## PROPOSED CHANGES TO THE DESIGN STANDARDS

# DOWNTOWN

## DESIGN STANDARDS

### CITY OF WI DELLS, WI

# Colors & Materials

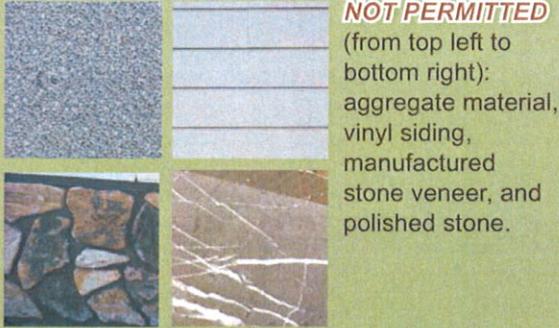
6. (P31) Moved up Standard 7 before Standard 5, and renumbered the remaining standards
7. (P32) Made many revisions per discussions at our last meeting, as well as with conversations with MSA architect, as listed below:

- b. Revised original Standard 3-5 to one standard prohibiting those discussed at the meeting – plus manufactured stone veneer (as shown in the left side bar). This is a fake look using concrete that is not a high-quality material and has subpar aesthetics. There are few buildings in the downtown that currently use this material, so some discussion may be warranted.

- e. There was a question related to the prohibiting of polished stone and want to note that honed stone would be allowed (see below). The polished (shiny) look is what you do not want to see, unless you deem it satisfactory.

- f. There was some discussion related to metal panel/siding systems in our last meeting. This material can be used with a positive result, but most of the time it is not (i.e. over used, used in the wrong portions of the building, or uses poorer quality material/design). Therefore, I added new Standard 4 and Standard 5 to mitigate the concerns. Standard 4 would not allow it to be used as a primary building material on facades facing the prime areas of concern (i.e. near Broadway Avenue and the river/riverwalk). Standard 5 would limit its use to 50% of the façade – plus does not allow it along the base of the building. I also provided the basic metal siding/panel

**NOT PERMITTED** (from top left to bottom right): aggregate material, vinyl siding, manufactured stone veneer, and polished stone.

**NOT PERMITTED** The above materials are not permitted as the primary building material on facades facing Broadway Avenue, cross streets of Broadway (up to alley) or river/riverwalk (from left to right): **corrugated metal**, **ribbed metal** and other panelized metal products.

Use of metal products as an accent material above the base of the building is allowed; however, use as a primary facade material is prohibited.

3. **Prohibited** building materials include gravel aggregate materials, vinyl siding, **manufactured stone veneer**, and polished stone.
4. **Metal panel/siding systems** (e.g., corrugated/ribbed panels) and other panelized products are **shall** only be used as an accent building material along Broadway Avenue, on cross streets to Broadway Avenue up to mid-block alley, or facing the river/riverwalk.

5. Where allowable, metal panel/siding systems (e.g., **corrugated/ribbed panels**) and other panelized products **shall not** cover more than fifty (50) percent of the facade and **shall not** be along the base of the building (minimum of three (3) feet above grade).

6. **EIFS** is **prohibited** at the base of the building where susceptible to damage (a minimum of three (3) feet above grade).
7. A picture and a sample of each exterior material and a facade illustration that indicates colors and materials **shall** be submitted with the Design Checklist.
